**Re: Trans Mountain Pipeline ULC (Trans Mountain)  
Trans Mountain Expansion Project (Project or TMEP)  
Certificate OC-065  
Request for Variance – Pipe Diameter, Coating and Wall Thickness  
Mountain 3 Horizontal Directional Drill  
CER File: OF-Fac-Oil-T260-2013-03 61**

### CONTINGENCY ALIGNMENT SHEET (SPREAD 5B)

**Mountain 3  
HDD Plan and Profile**

**HDD Pullback Plan and Profile**

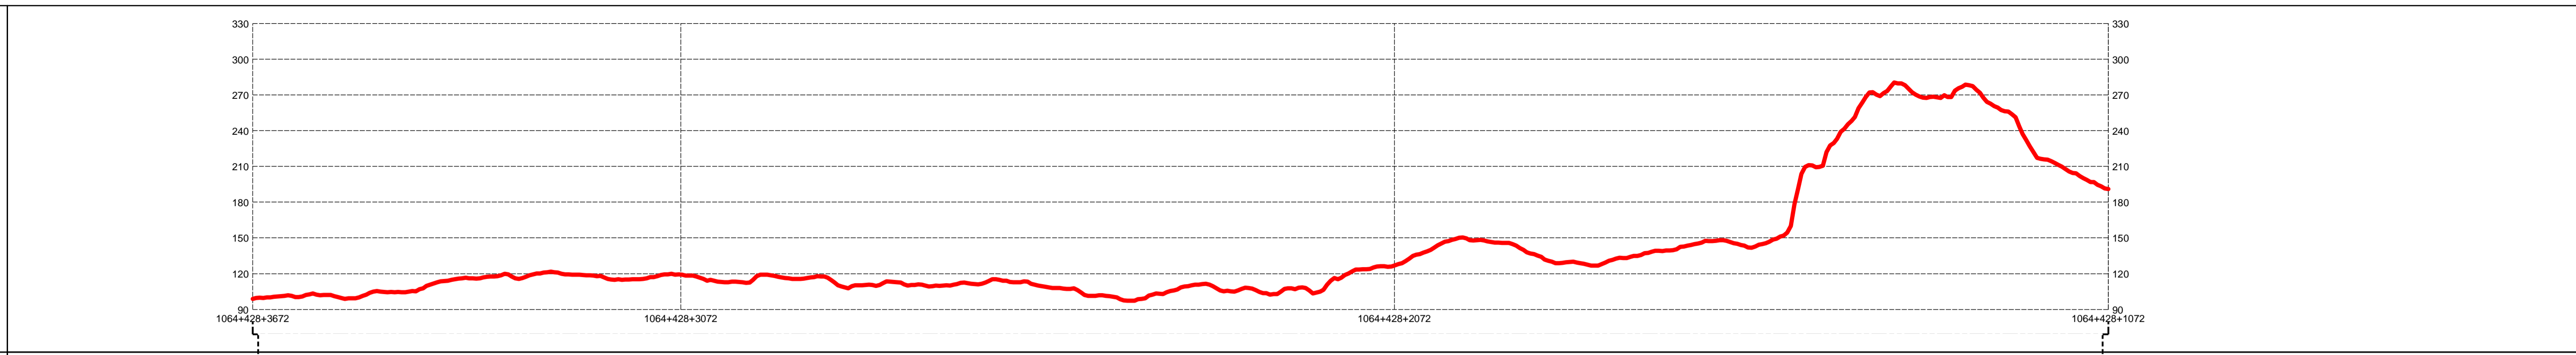
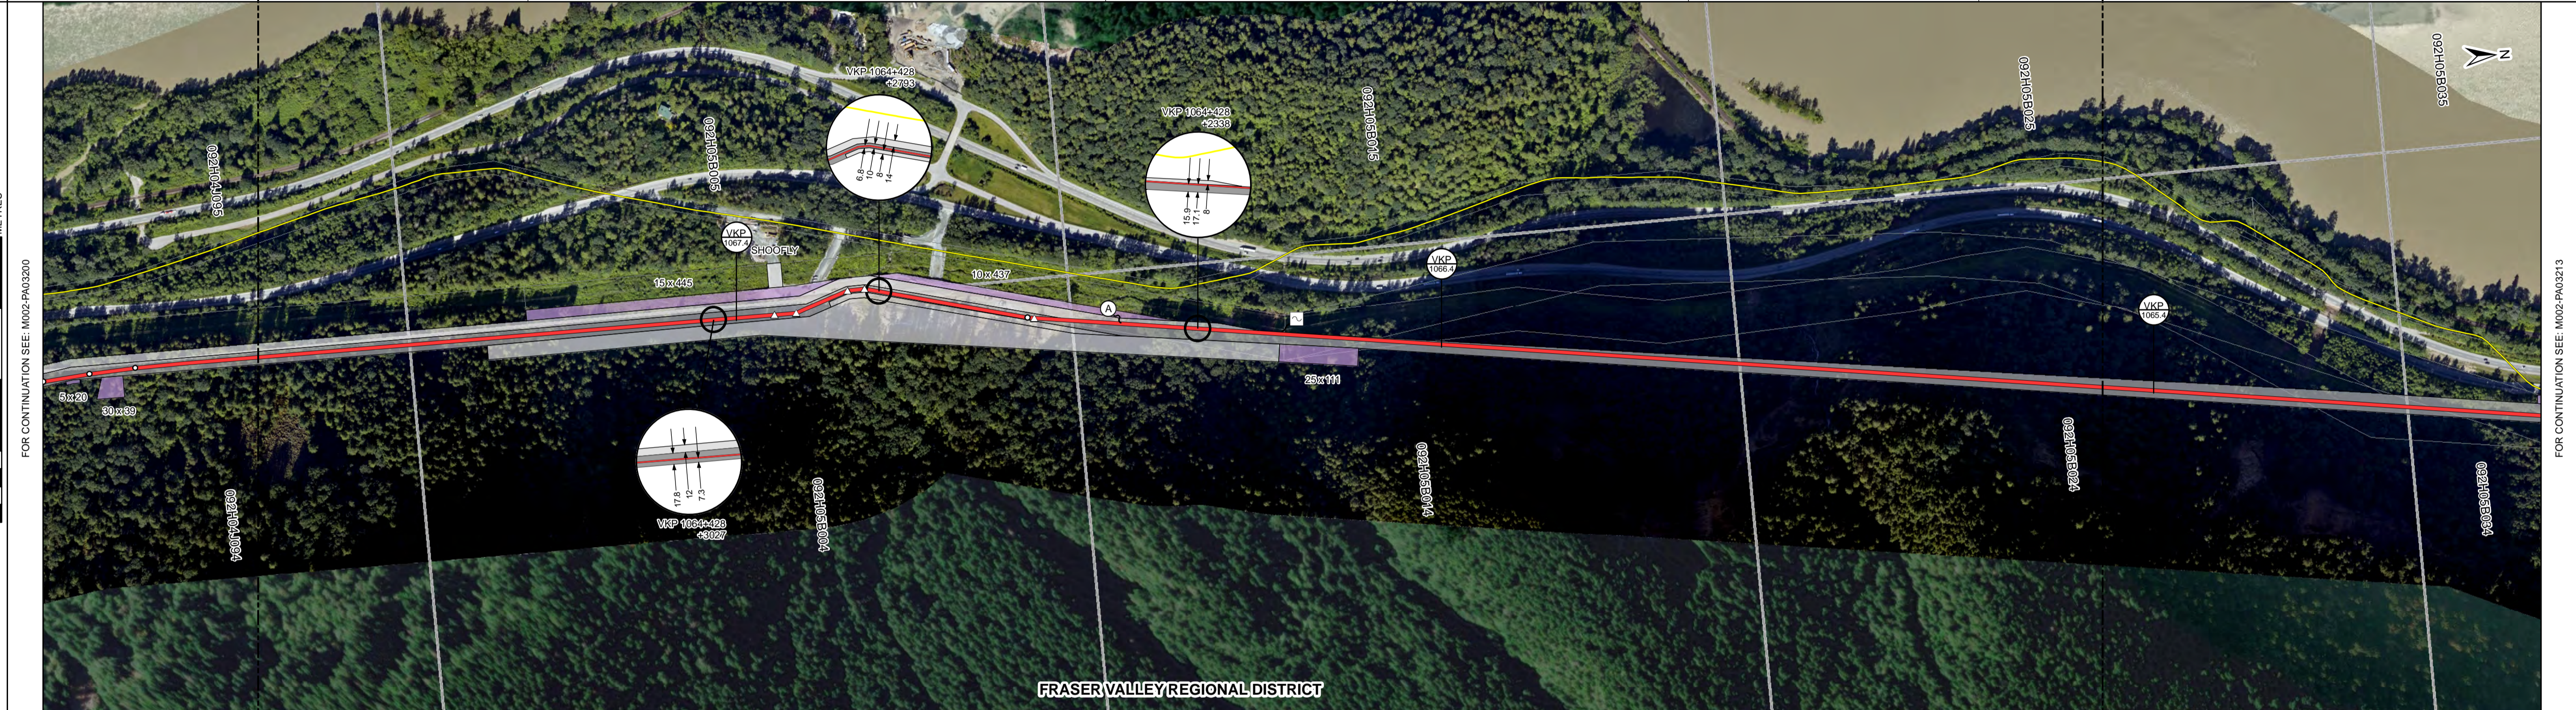
Engineering Alignment Sheets that illustrate and provide detail on the NPS 30 installation are provided in Attachment 2. The NPS 30 pipe will be ARO-coated, 15.9 mm wall thickness for the entire length of the crossing, and induction bends will be 19 mm wall thickness. This configuration, determined using a design factor of 0.8 and class location of 1, maintains the current design factor of safety for the Mountain 3 HDD crossing.

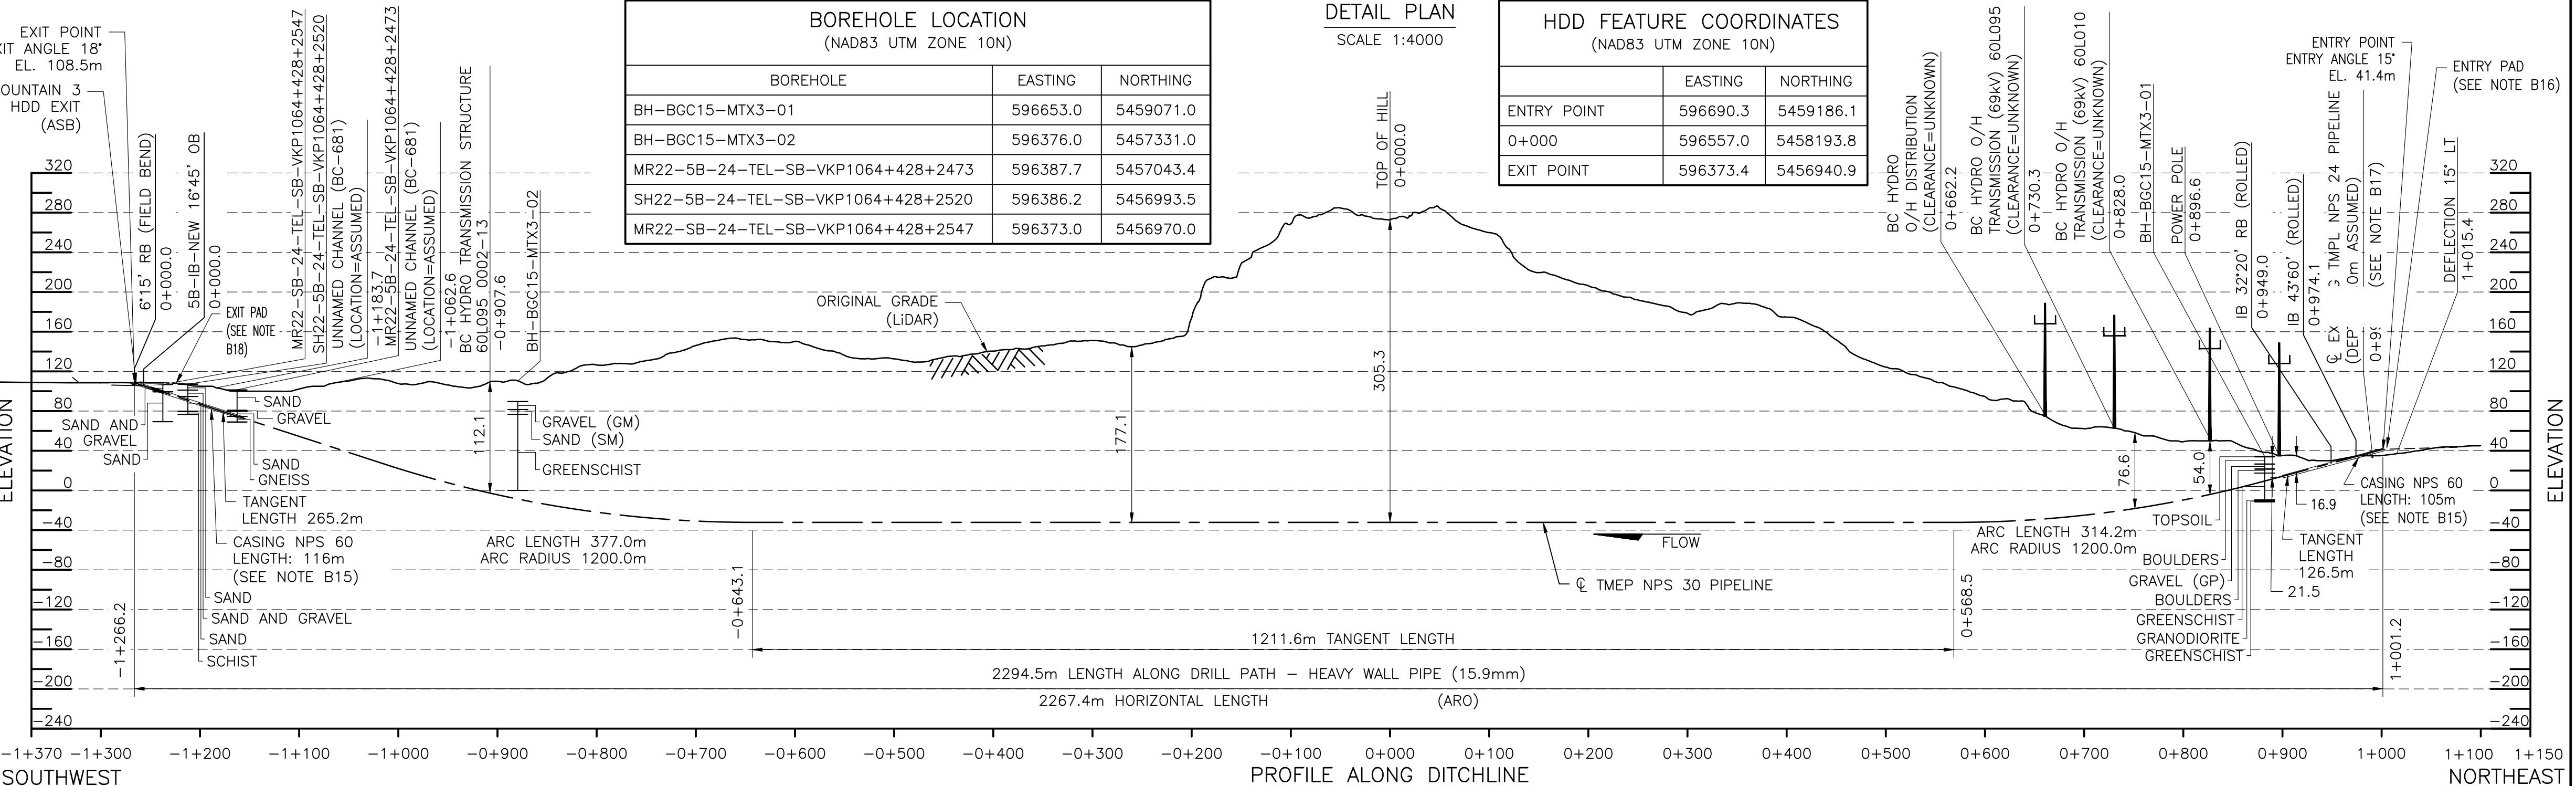
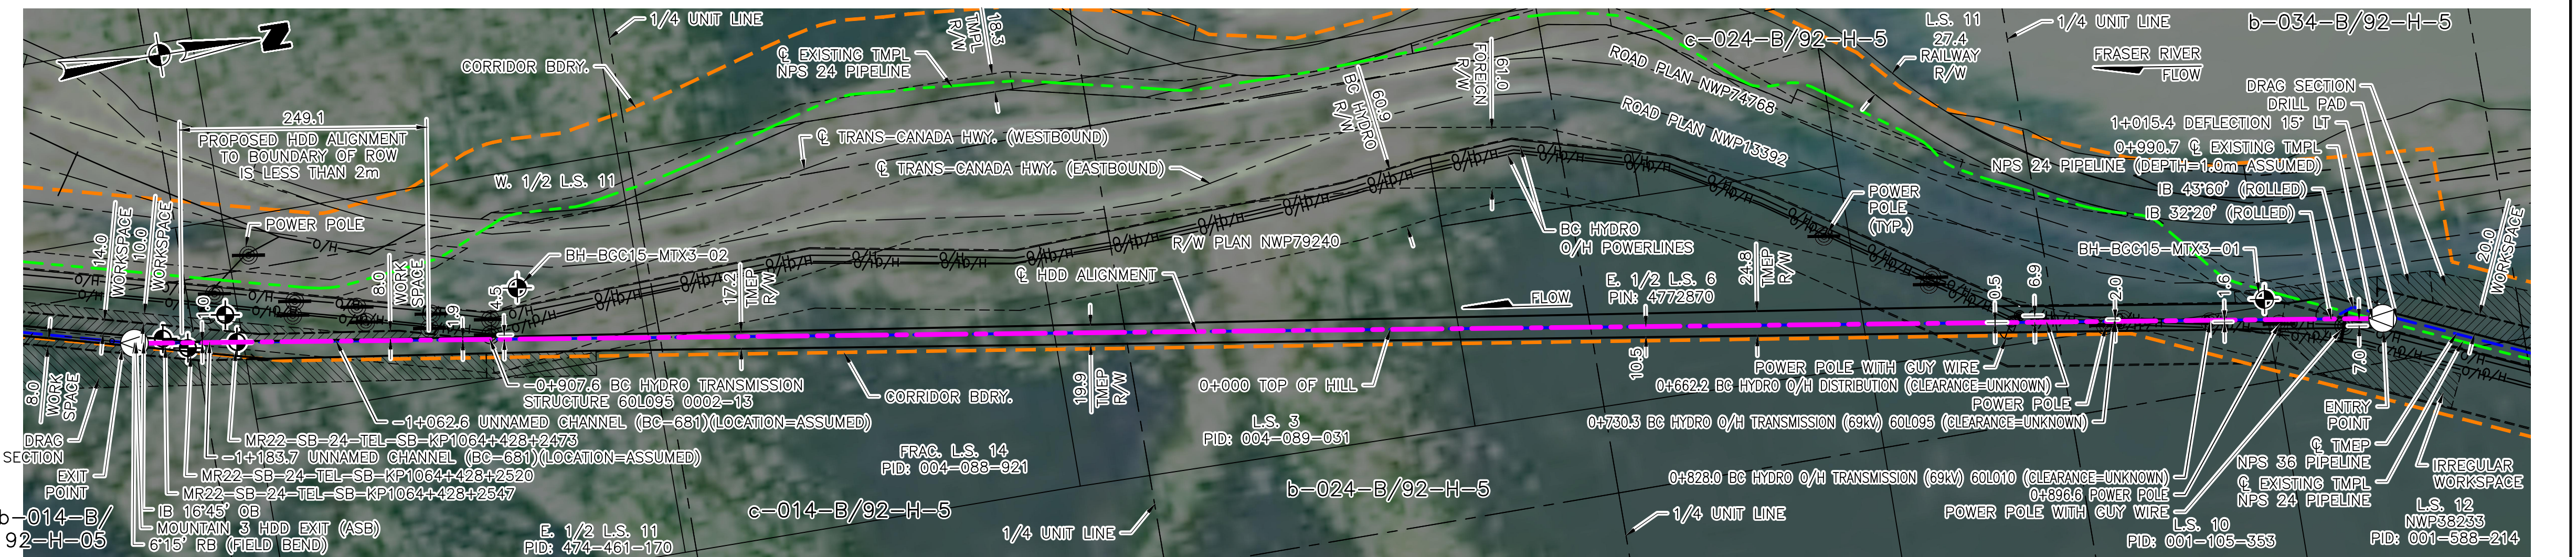
A plan and profile of the NPS 30 HDD is provided as Attachment 3. A plan and profile of the NPS 30 HDD pullback is provided as Attachment 4.

# Mountain 3 HDD: NPS 30 pipe instead of NPS36 - Summer

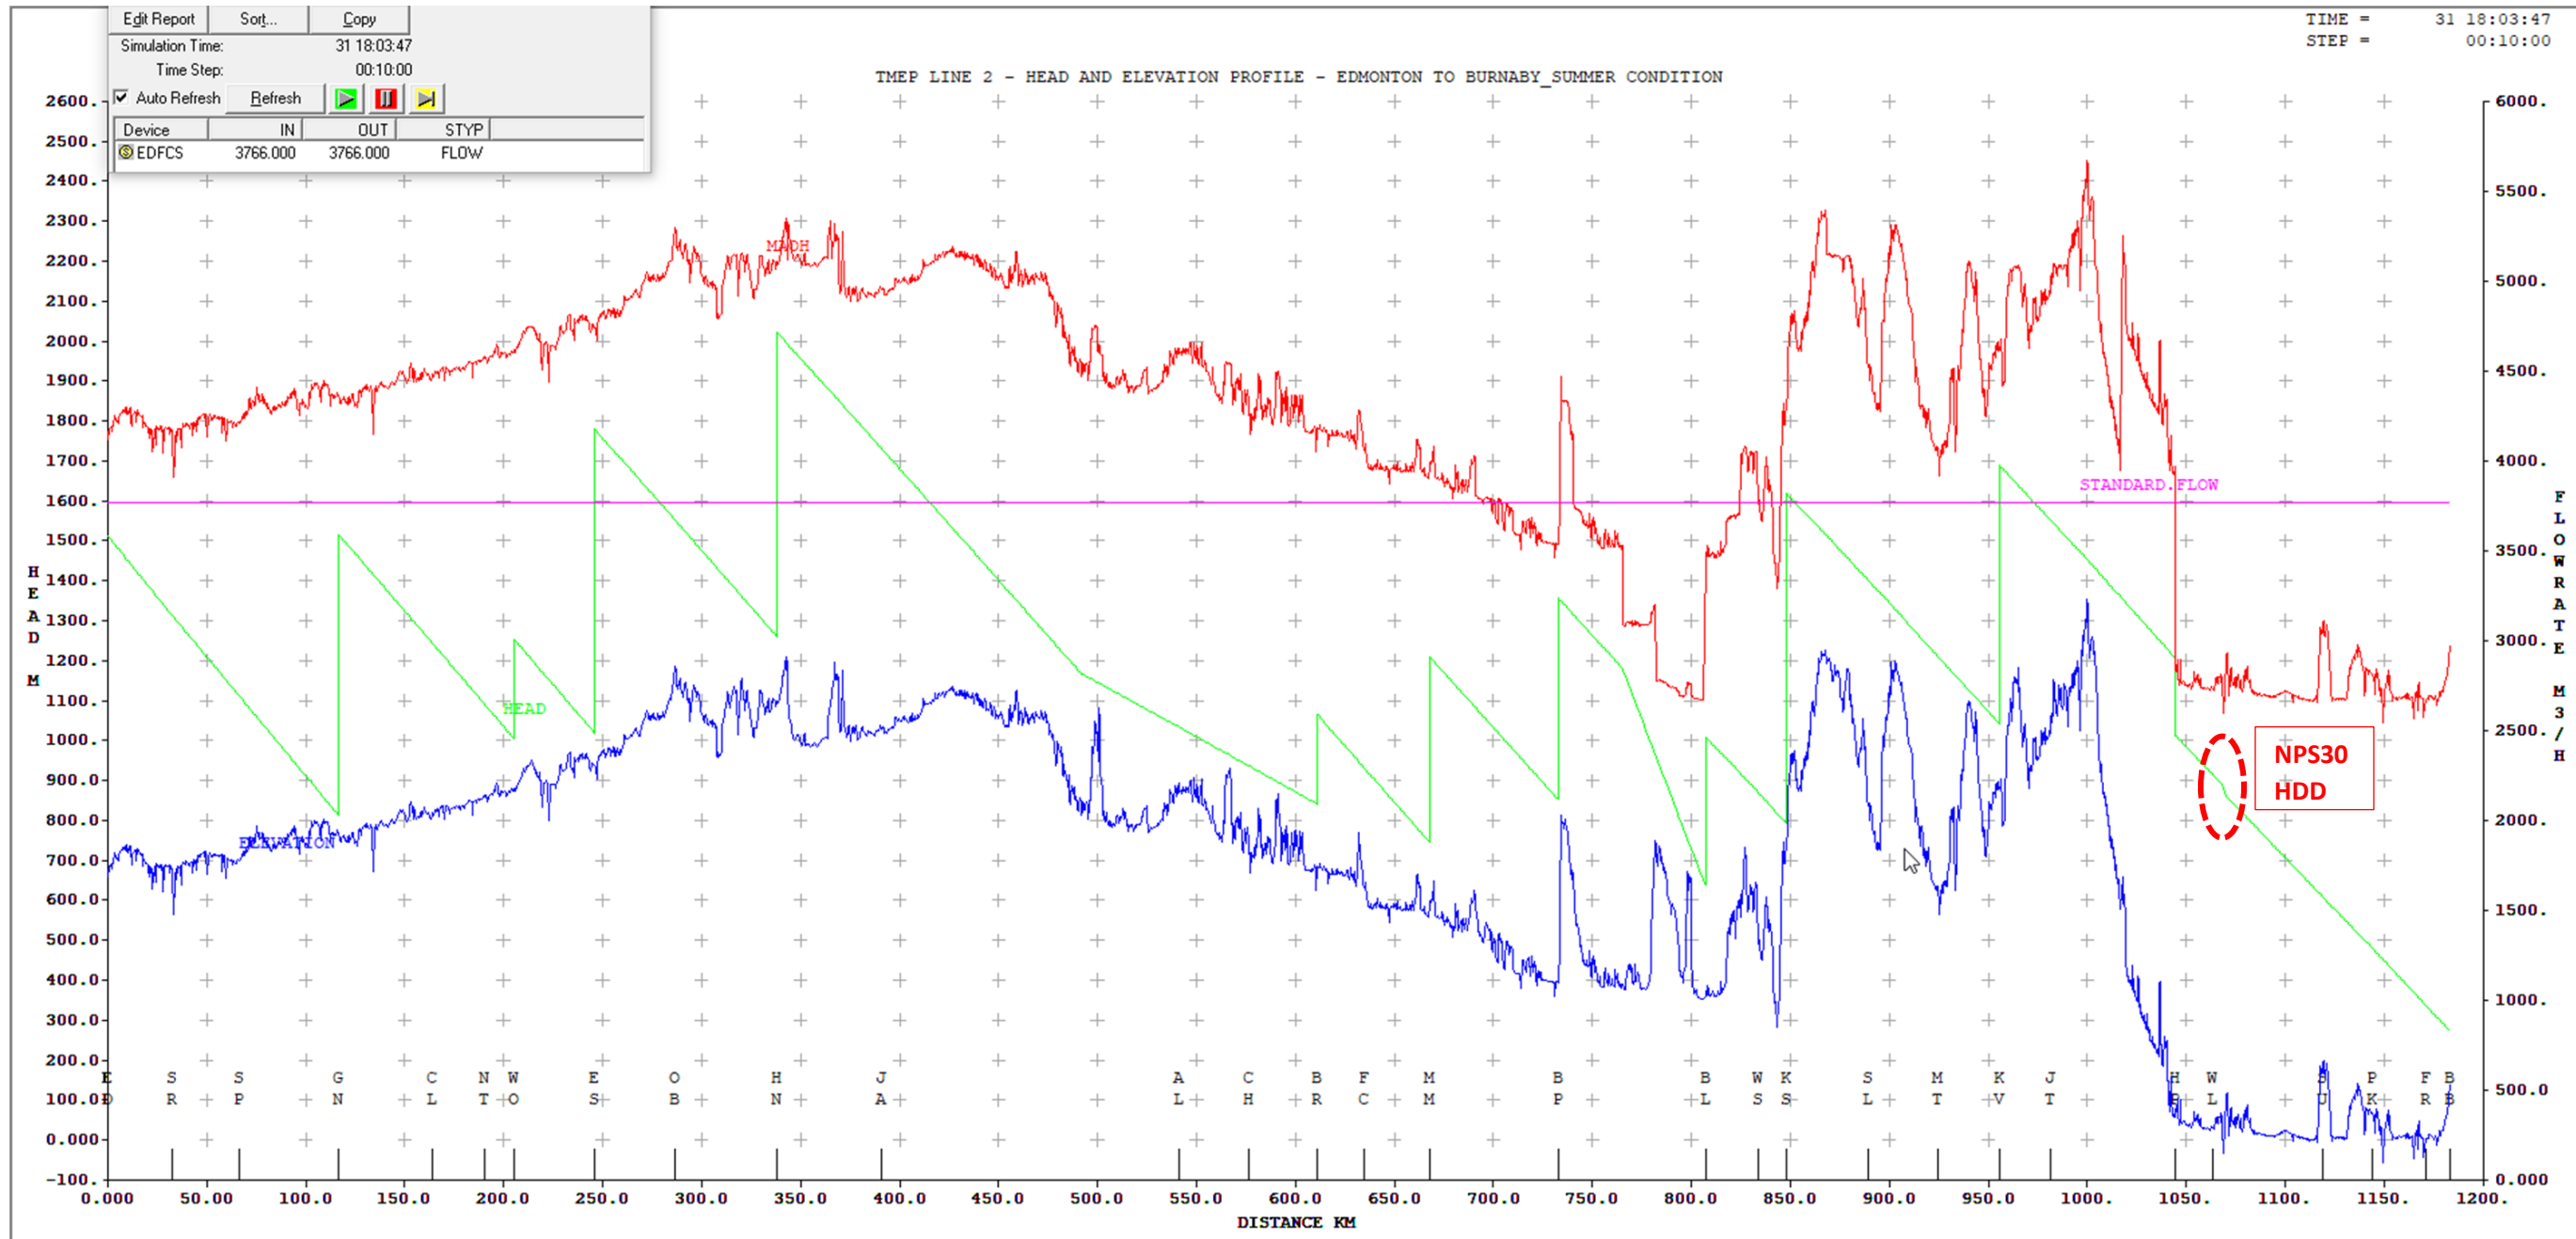
No throughput impact, the design flow rate 568,400 bpd (3766m3/hr) can be achieved.

No throughput impact, the design flow rate 568,400 bpd (3766m3/hr) can be achieved.
